GROUP	MODEL
BOD	2021-2024MY Seltos (SP2)
NUMBER	DATE
326 (Rev 1, 10/20/2025)	July 2024

TECHNICAL SERVICE BULLETIN

HORN ASSEMBLY INSPECTION/REPLACEMENT

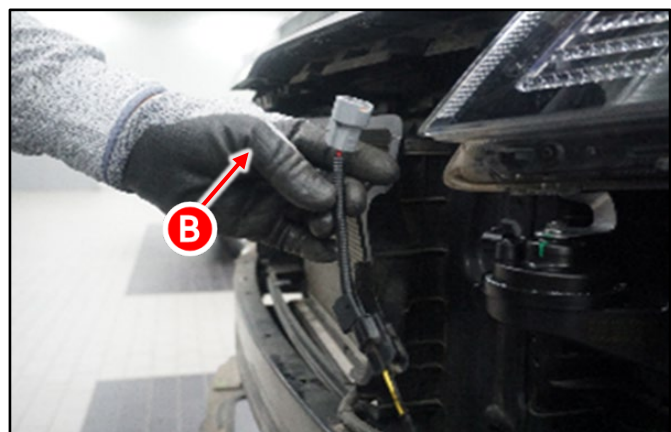
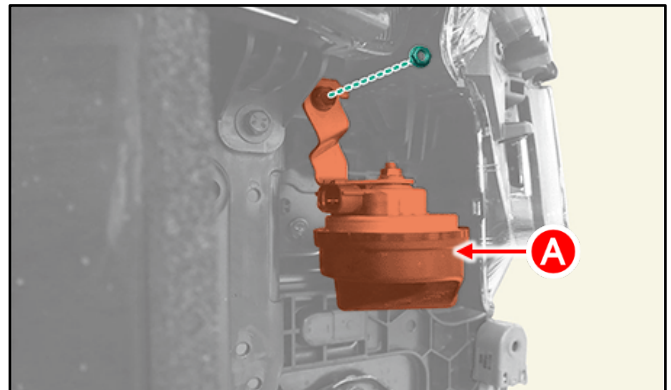
The replacement horn has reversed polarity compared to the original. Use the supplied extension harness to ensure proper connection.

- Replace the Horn (B) by referring to "Body Electrical System → Horn → Repair procedures" in the applicable Shop Manual on KGIS.
 - 21-23MY Seltos**
96611 Q5000QQK or **96641 Q5000QQK***
 - 2024MY Seltos**
96611 Q5100QQK or **96641 Q5200QQK**

21-23MY ONLY: If replacing the horn with **PN 96641 Q5000QQK*, it is required that the wiring harness extension (B) is also replaced simultaneously.**
